**ADDENDUM NO 1  
TO  
CONTRACT DOCUMENTS  
FOR  
JA-3 Cathodic Protection System  
[DISTRICT PROJECT NO.: 4223}**

**12/03/2021**

JVWCD  
 JORDAN AQUEDUCT - REACH 3 (JA3)

JA3 CATHODIC PROTECTION SYSTEM  
 DESIGN PROJECT

**CPS SCHEDULE**

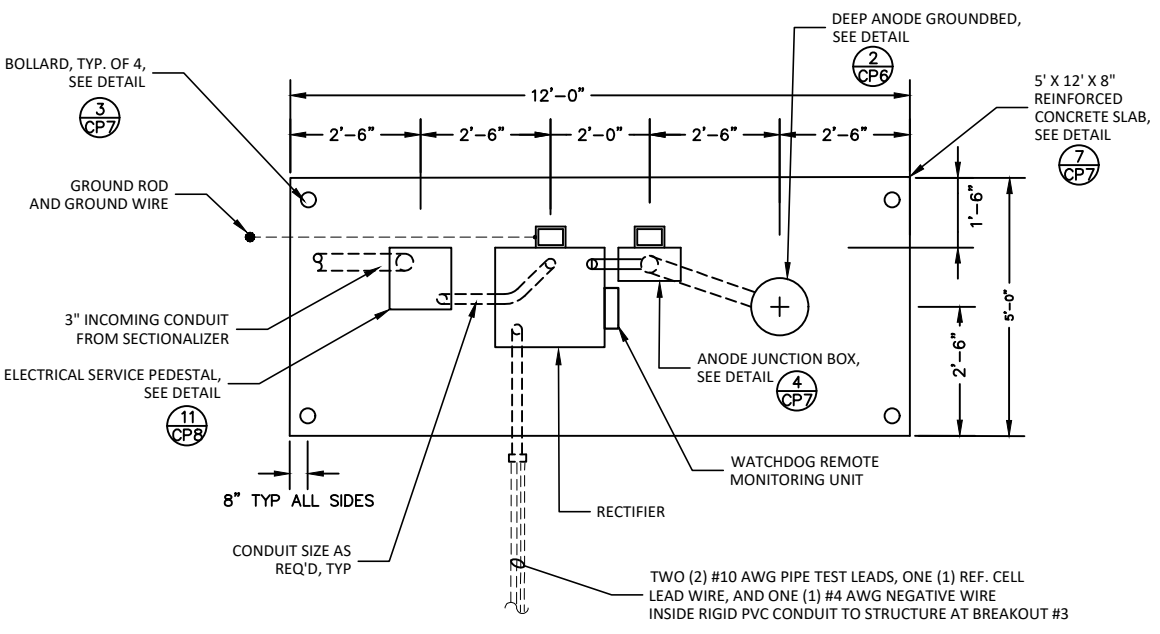
1. Drawing CP-6 is updated to specify the voltage/amperage requirements for the rectifier.
2. The date of the bid opening remains December 15<sup>th</sup> at 2:30 pm.

DSGN	ESL					
DR	ZGS	2	2021-12-03	REV 1 - CATHODIC PROTECTION SCHEDULE UPDATE	ZGS	ESL
CHK	ESL	1	2021-11-12			
APVD	ESL	NO.	DATE	ISSUE/REVISION	BY	APVD

CATHODIC PROTECTION SCHEDULE	
<b>RECTIFIER OUTPUT</b>	
DC VOLTAGE OUTPUT	35
DC AMPERES OUTPUT	25
<b>DEEP ANODE GROUND BED</b>	
NUMBER OF ANODES	12
ANODE TYPE	TA3 CHROMIUM HIGH SILICON TUBULAR ANODES, 63 LBS, 84" LONG, 2.66" DIAMETER EACH
TOTAL GROUND BED LENGTH	300'
ACTIVE COLUMN LENGTH	115'
LORESCO SC3 BACKFILL FOR ACTIVE COLUMN	115'
BENTONITE FOR INACTIVE COLUMN	185'
ANODE SPACING	8' ON CENTER (O.C.)
VENT PIPE STYLE	ALL-VENT
BELOW GRADE PVC SURFACE CASING LENGTH	100' MIN.
WELL HOLE DIAMETER	8"
